Access Compliance Report

Public Rights-of-Way

(Curb Ramps)

Intersection ID: 47902	Main Street: SPUR_RANCH_RD	Cross Street: ROUND_ROCK_RD	Location: SE
ADA ID: A2B480590D66	Ramp Type: PerpDiag	Initial Pass/Fail: Fail	Overall Compliance: No
		Severity Score: 8.75

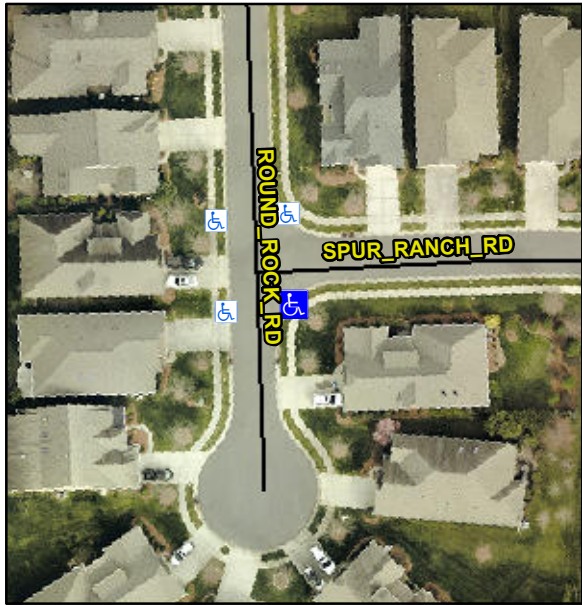
Codes/Mitigation Info/Possible Solution			Field Measurements/Component Compliance					
	Possible Solutions:		Compliance	Description	Data	Compliance	Description	Data
	Remove & Replace Curb Ramp With Two New Directional Ramps or Equivalent.		N/A	Ramp Length (in)	46.0	Yes	Ramp Slope (%)	6.0
			No	Ramp Width (in)	46.0	Yes	Ramp XSlope (%)	1.4
			N/A	Flare Type LT	N/A	N/A	Flare Type RT	N/A
			N/A	Flare Slope LT (%)	N/A	N/A	Flare Slope RT (%)	N/A
			N/A	Flare Traversable LT?	N/A	N/A	Flare Traversable RT?	N/A
			N/A	Landing Length (in)	N/A	N/A	DWS Provided?	N/A
			N/A	Landing Width (in)	N/A	N/A	DWS Contrast?	N/A
			N/A	Landing Slope (%)	N/A	N/A	DWS Length (in)	N/A
			N/A	Landing X Slope (%)	N/A	N/A	DWS Full Width?	N/A
Surveyor Notes:	N/A		N/A	Landing Curb? (Y/N)	N/A	N/A	DWS Offset (in)	N/A
			N/A	Shared Landing?	N/A			
	PROW/ADA:		N/A	Gutter Ponding?	N/A	N/A	Gutter Slope (%)	N/A
	Not Found, R304.5.1		N/A	Gutter Lip Ht (in)	N/A	N/A	Gutter X Slope (%)	N/A

Not Found, R304.5.1

Remove & Replace Curb Ramp With Two New Directional Ramps or Equivalent.
